MEMORANDUM

SUBJECT: Professional Wetland Peer Review Services
CP Endeavor Holdings 18 LLC
Shea Drive and MA state Route 18
Weymouth, MA

FEMA has identified a flood zone at the site as shown below

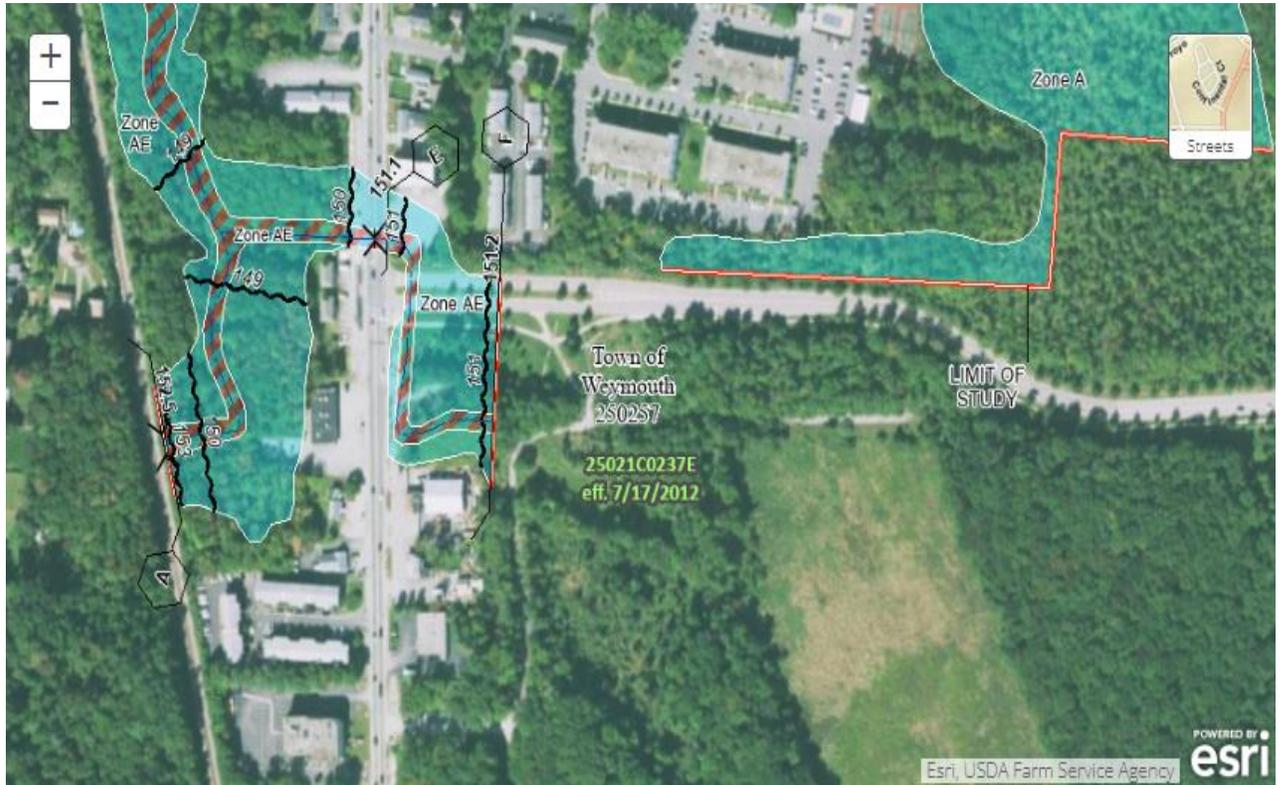
As shown, the hotel and parking are proposed within a regulatory floodway and the 100-year flood zone, identified as AE Zone 10. The flood elevation lies between 151.1 and 151.2 (NAVD88), pre the above image. There are no published Letter of Map Amendments (LOMA) for this area, as of this date. Thus, any Notice of Intent must provide compensatory flood storage for fill within the blue shaded areas.
